RE: Agreement No. 1406
Traffic Impact Study Services
Task 233A-Palomar North and South

Johnson, Mirmiran and Thompson (JMT) has completed the review of the Traffic Impact Study (TIS) for the Palomar North and South, prepared by Van Cleef Engineering Associates, dated May, 2010. This review was assigned Task Number 233A. Van Cleef Engineering Associates prepared the report in a manner generally consistent with DelDOT's *Standards and Regulations for Subdivision Streets and State Highway Access*.

Palomar North and South

| N.T.S | FIGURE 1 | DECEMBER, 2010 | |

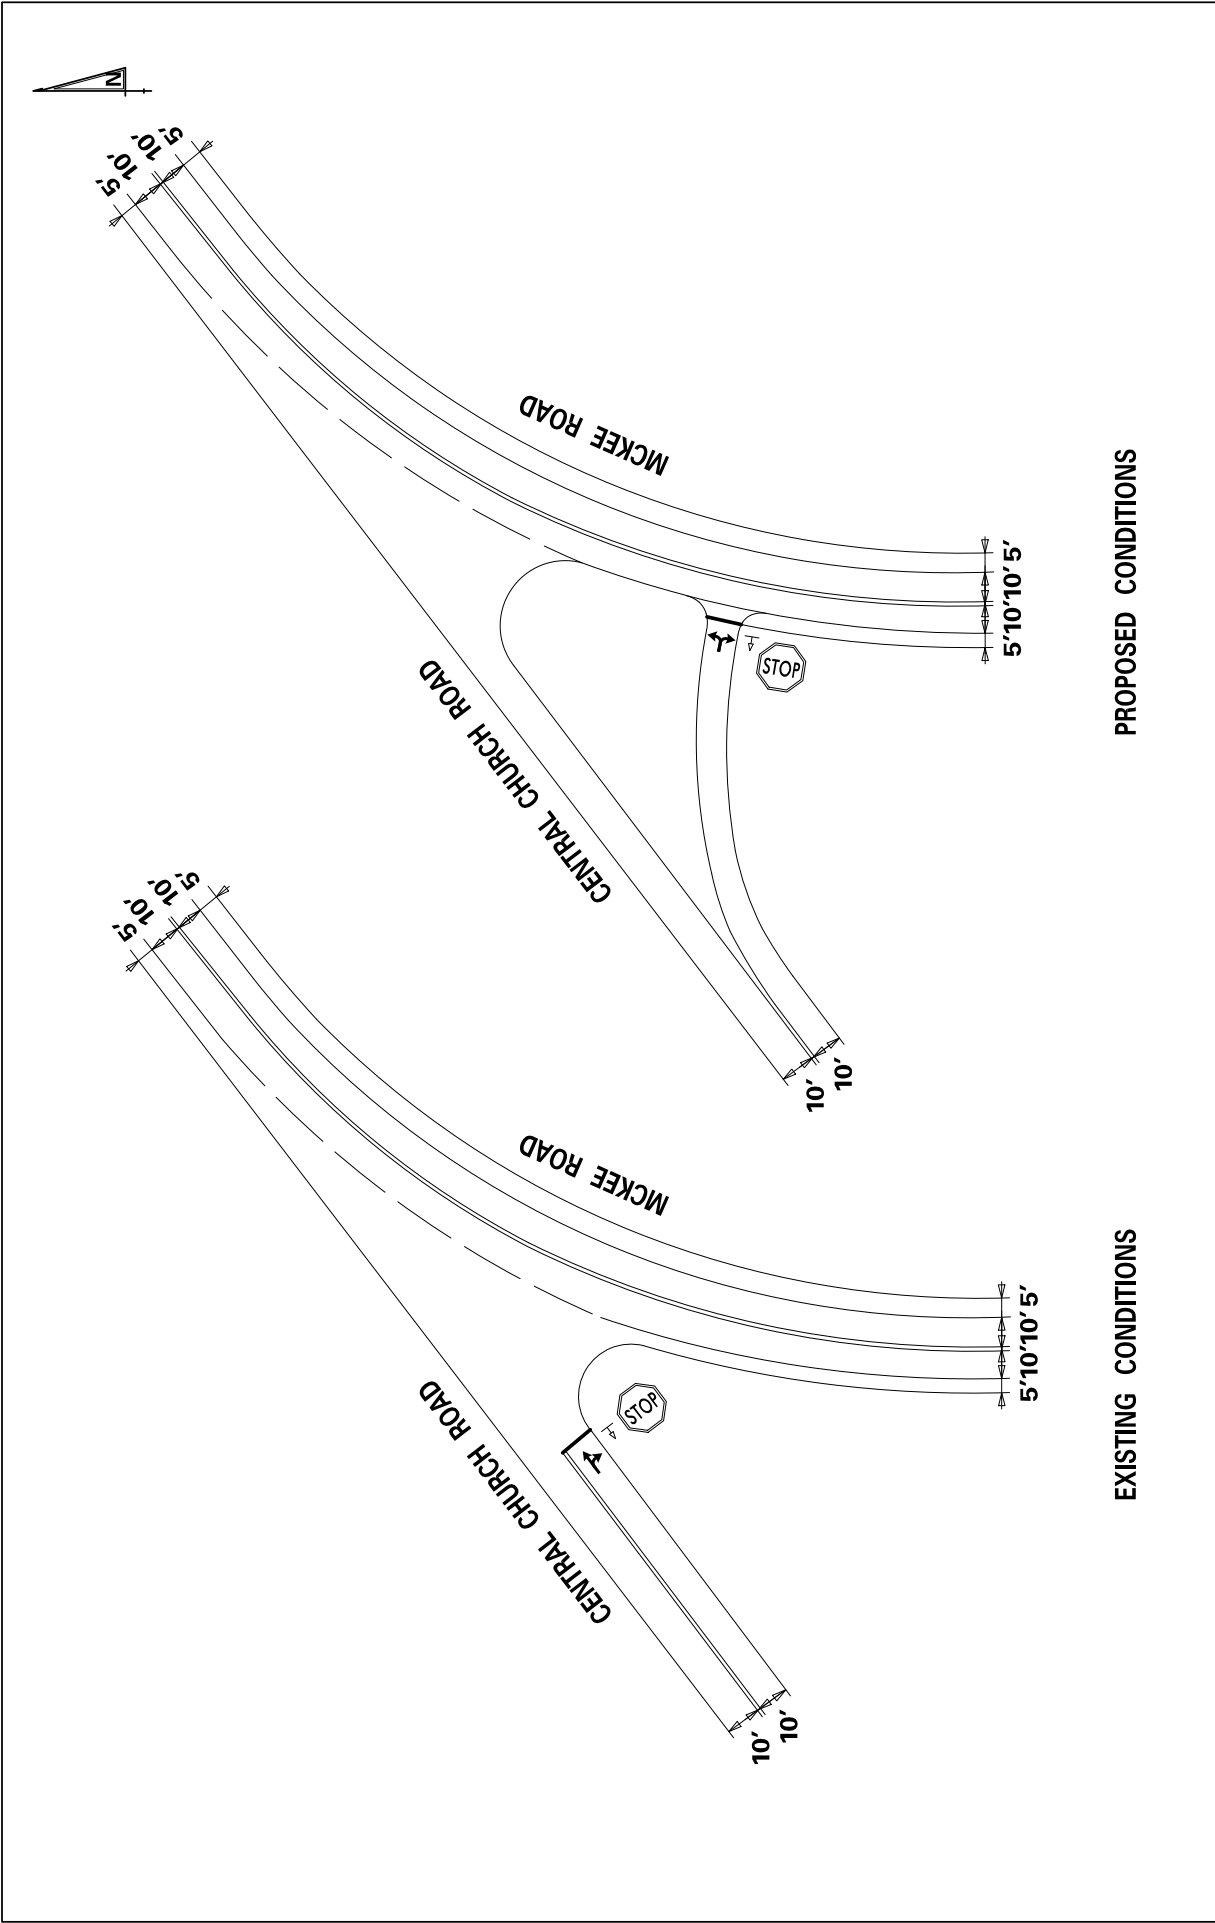
While the intersection of McKee Road and Central Church Road would operate with acceptable LOS under all future conditions, the northbound McKee Road alignment and the eastbound Central Church Road stop control treatment present operational issues. Currently northbound and westbound McKee Road operate as free flow movements and eastbound Central Church Road operates as stop controlled. The geometric layout of the intersection would make it difficult for eastbound Central Church Road motorists to turn onto southbound and eastbound McKee Road. In addition, the future traffic growth patterns (Case 2 and Case 3) indicate that more traffic is

expected on eastbound Central Church Road approach than northbound McKee Road approach at this intersection. We recommend that the eastbound Central Church Road approach be realigned as such the eastbound Central Church Road connects with McKee Road as a T-intersection. With this modification motorists who would turn from Central Church Road onto McKee Road would have longer sight distance. The geometry of northbound and westbound McKee Road would remain as it is. Based on this modified T-intersection layout, the intersection of Central Church Road and McKee Road would operate with acceptable LOS under all future conditions. The intersection conceptual improvement plan is shown as Figure 1 on page 8.

8. The developer should improve the intersection of McKee Road and Central Church Road by realigning the eastbound Central Church Road to be perpendicular to the northbound McKee Road. This should also include relocating the stop sign on the eastbound Central Church Road approach. The intersection conceptual improvement plan is shown as Figure 1 on page 8. Preliminarily, it appears that this improvement can be built within the existing right-of-way. To the extent possible, that should be done.
